NAVIGATION - STALL WARNING HORN REPLACEMENT

This service document provides parts and instructions to remove the original stall warning horn and wiring, drill a hole in the mounting plate and install a new stall warning horn, wiring connector.

CAB-34-11  
Page 1 of 12

Figure 1. Stall Warning Horn Replacement (Sheet 1)

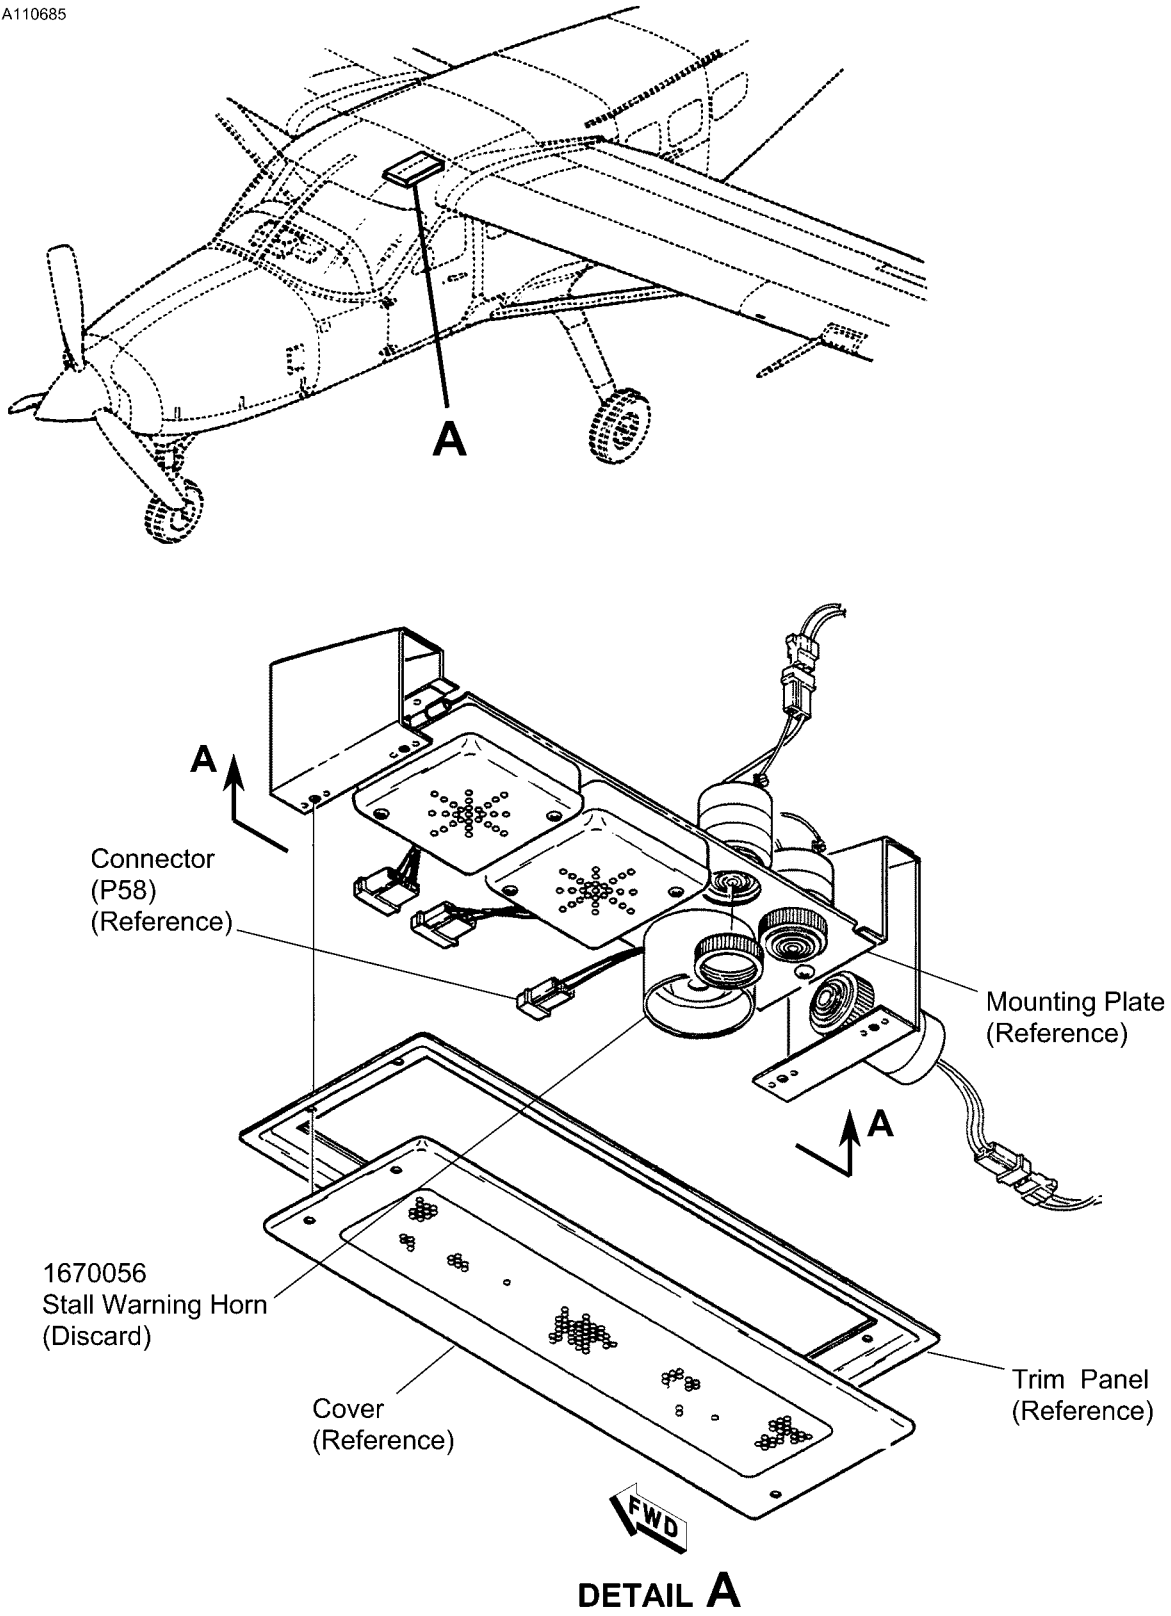
2. (Refer to Figure 1, Sheet 1.) Remove the screws that attach the cover, and trim panel to the headliner above pilot seat.
  - A. Remove the cover and trim panel from the mounting plate.

- B. Remove screw at the aft end of the mounting plate.  
**NOTE:** These are the screws that attach the mounting plate to the bracket and allow the mounting plate to swivel downward.

- C. Pull the aft end of the mounting plate down.
  - D. Identify and disconnect the electrical connector for the stall warning horn.
  - E. (Optional) Remove the hinge pin and remove the mounting plate. (Refer to the Model 208 Series Maintenance Manual, Chapter 27, Stall Warning System - Removal/Installation.)

3. (Refer to Figure 1, Sheet 1.) Remove the stall warning horn from the mounting plate and discard.
  4. (Refer to Figure 1, Sheet 2.) Do a modification of the mounting plate.

- C. Install the knurled nut on the SC648NDR Horn and hand tighten.
7. (Refer to Figure 1, Sheet 1.) If removed, install the mounting plate and hinge pin. (Refer to the Model 208 Series Maintenance Manual, Chapter 27, Stall Warning System - Removal/Installation.)

8. Connect electrical connector PC012 to JC012 for the stall warning horn.
9. (Refer to Figure 1, Sheet 1.) Close the 2613366-2 Mounting Plate access for the warning horns and sirens above the pilot seat. (Refer to the Model 208 Series Maintenance Manual, Chapter 27, Stall Warning System - Removal/Installation.)

- A. Push the aft end of the mounting plate up and install the kept screws.
- B. Put the cover and trim panel into position and install with kept screws.

Figure 1. Stall Warning Horn Replacement (Sheet 2)

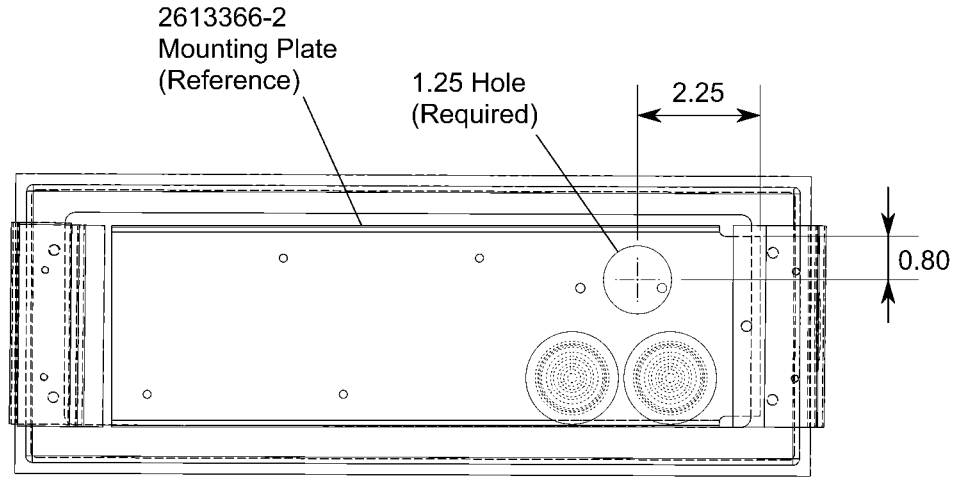
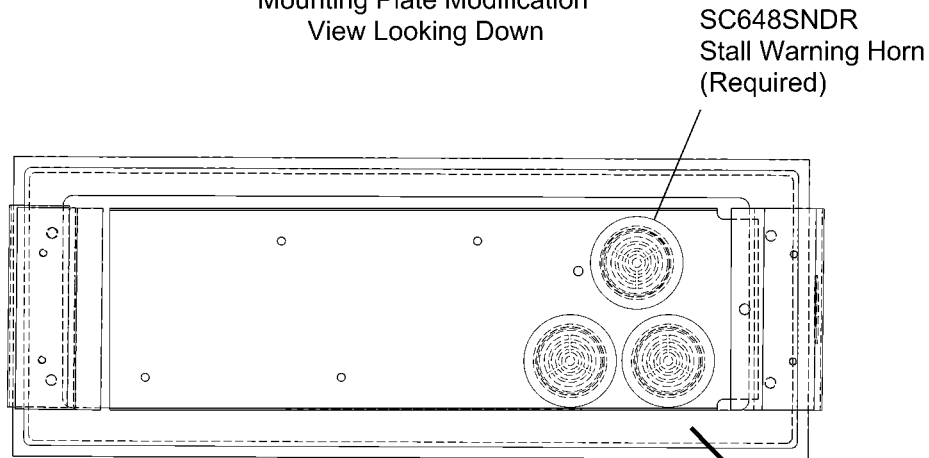
- A. Identify the location for the 1.25 Inch-Diameter hole.
    - B. Cut a 1.25 Inch-Diameter hole at the identified location.
    - C. Deburr the cut hole.

- D. Apply Color Chemical Film Treatment to the bare aluminum surface.
  5. (Refer to Figure 2, Sheet 1.) Buildup the wire harness for the SC648NDR Horn as follows:

Figure 2. Stall Warning Horn Wiring Modification (Sheet 1)

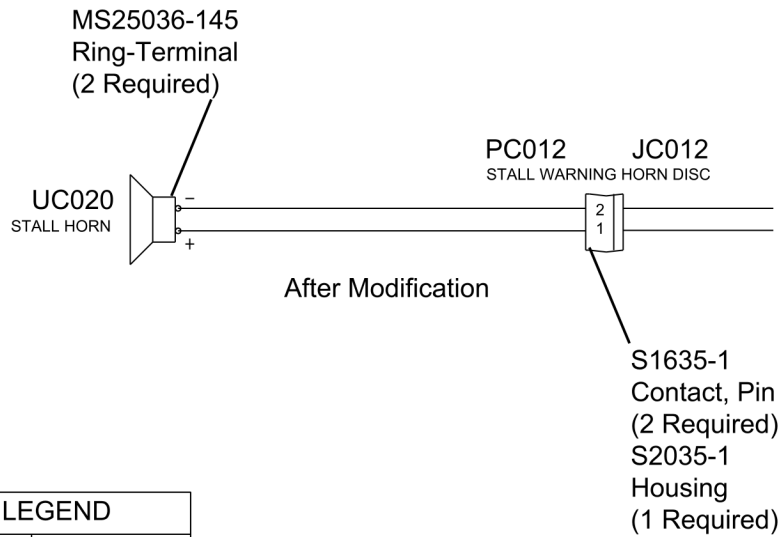
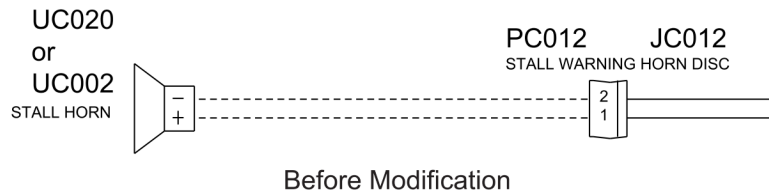
- A. Cut the C489242 (M81044/12-22-9) Electrical Wire into two equal lengths.
    - B. Install two S1635-1 Pins, one on each wire. (Refer to the Model 208 Series Wiring Diagram Manual, Chapter 20, Electrical Connectors - Maintenance Practices.)

- C. Install the wires and S1635-1 Pins into the S2035-1 Housing. (Refer to the Model 208 Series Wiring Diagram Manual, Chapter 20, Electrical Connectors - Maintenance Practices.)

**NOTE:** Positive (+) terminal to Pin 1 of PC012 and Negative (-) Terminal to Pin 2 of PC012. Pin 1 will have a protrusion on the S2035-1 Housing.
    - D. Install the TMS-SCE3/32-2.0-9 Identification Sleeves Marked POSUC020-1PC012 on each end of the wire inserted into the housing at Pin 1 location.

- E. Install the TMS-SCE3/32-2.0-9 Identification Sleeves Marked NEGUC020-2PC012 on each end of the wire inserted into the housing at Pin 2 location.

- F. Install one MS25036-145 Ring Terminal on the free end of each wire. (Refer to the Model 208 Series Wiring Diagram Manual, Chapter 20, Splices and Terminals - Maintenance Practices.)

- G. Use a MS35206-245 Screw and connect the MS25036-145 Ring Terminal from Pin 1 of PC012 to the positive (+) terminal on the SC648NDR Horn.
    - H. Use a MS35206-245 Screw and connect the MS25036-145 Ring Terminal from Pin 2 of PC012 to the negative (-) terminal of the SC648NDR Horn.

- I. Install the S4111-1A Nameplate marked with PC012 on the wires next to the S2035-1 Housing with two S2209-7 Tie Straps.
    - J. Install the S4111-1A Nameplate marked with UC020 on the wires next to the SC648NDR Horn with two S2209-7 Tie Straps.

Figure 2. Stall Warning Horn Wiring Modification (Sheet 2)

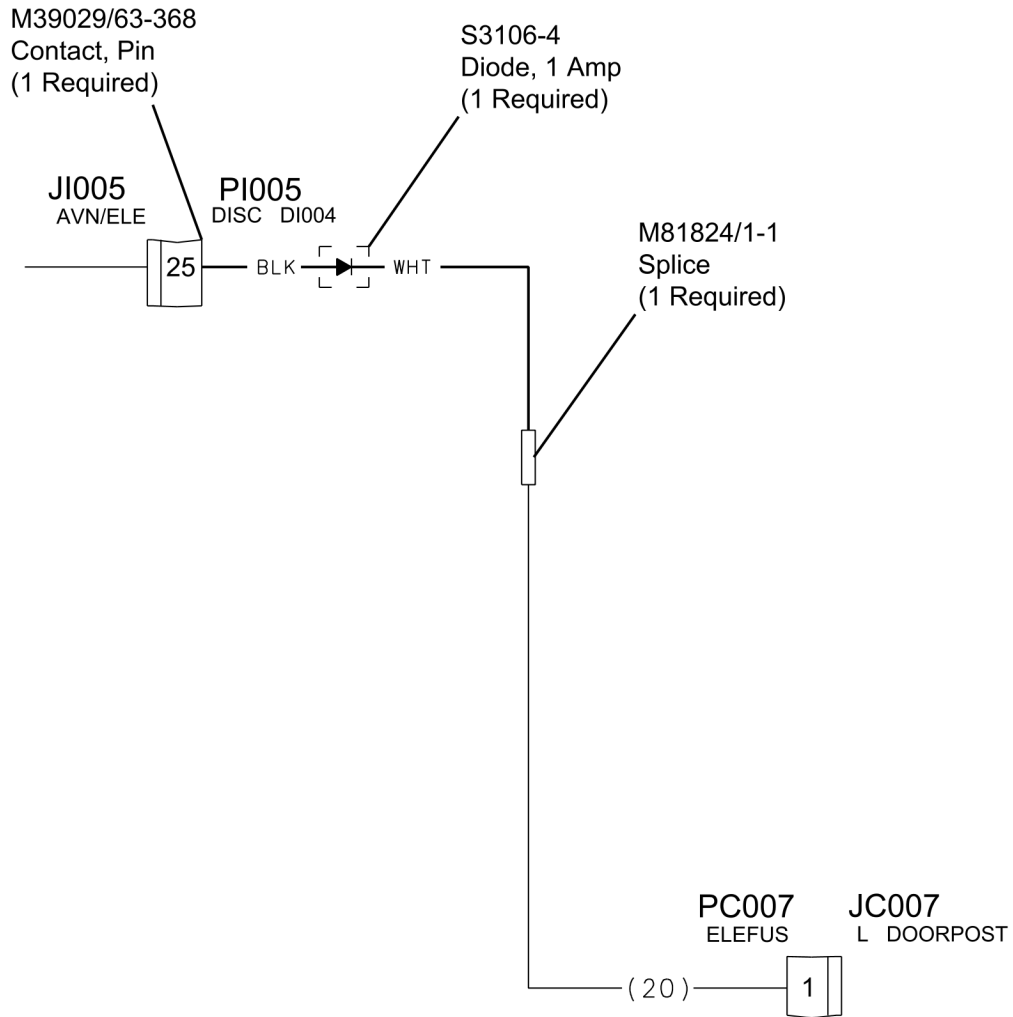
10. (Airplanes 208: 20800001 thru 20800670 Refer to Figure 2, Sheet 2, and airplanes 208B 208B0001 thru 208B5615, Refer to Figure 2, Sheet 3.) Do the wiring modification to install the S3106-4 Diode as follows:

- A. Install a M39029/63-368 on BLK lead from the S3106-4 Diode.
- B. De-pin wire 25PI005 and cut off the Contact Pin from the wire.
- C. Install BLK lead from the S106-4 Diode with the new M39029/63-368 Pin into 25PI005.
- D. Use a M81824/1-1 Splice and connect the WHT lead from S3106-4 Diode to the cut wire that was removed from 25PI005.
11. Remove the maintenance warning tags and connect the airplane battery.
12. Complete the stall warning system operational check. (Refer to the Model 208 Series Maintenance Manual, Chapter 27, Stall Warning System - Inspection/Check.)
- NOTE:** This check is to make sure that the stall warning horn sounds, it is not necessary to do the heat check of the stall vane identified in the maintenance manual procedure.
13. Make an entry in the airplane logbook that states compliance and method of compliance with this service document.

Figure 2. Stall Warning Horn Wiring Modification (Sheet 4)

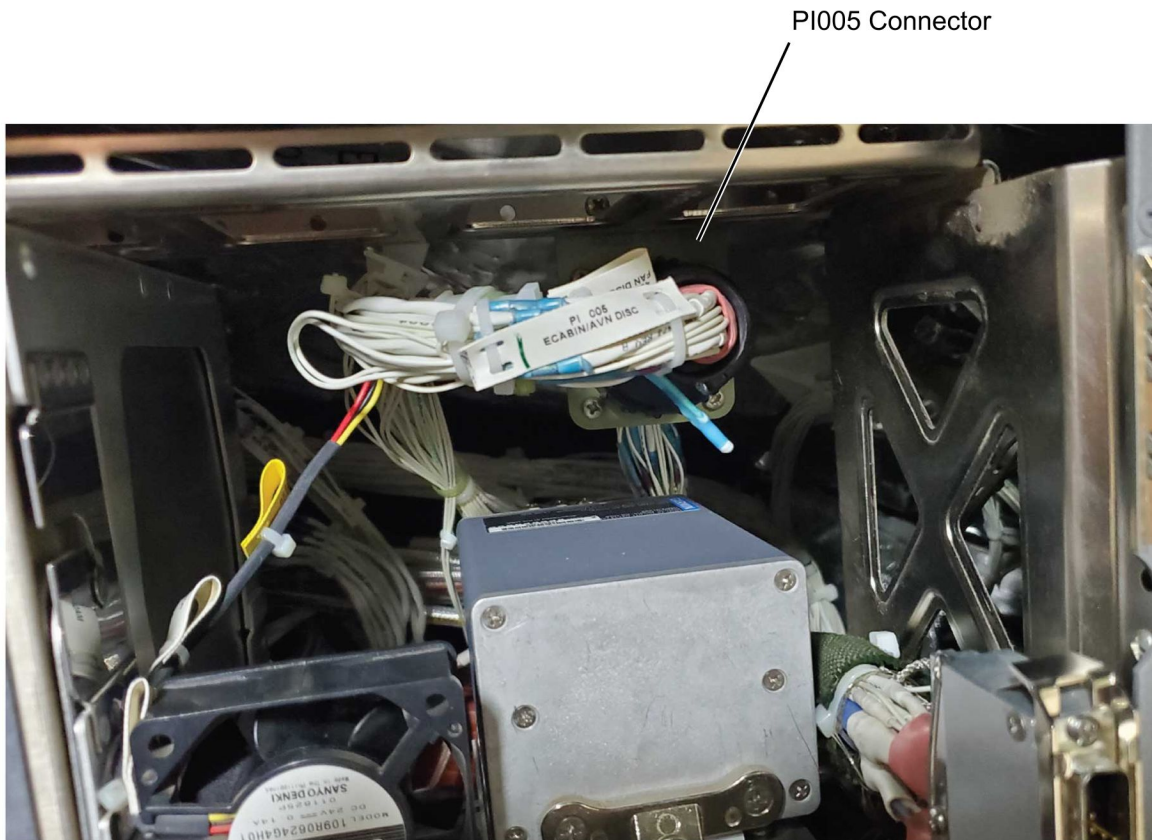
**NOTE:** PI005 is the round black connector located behind PFD2, there is a picture in Figure 2, Sheet 4.
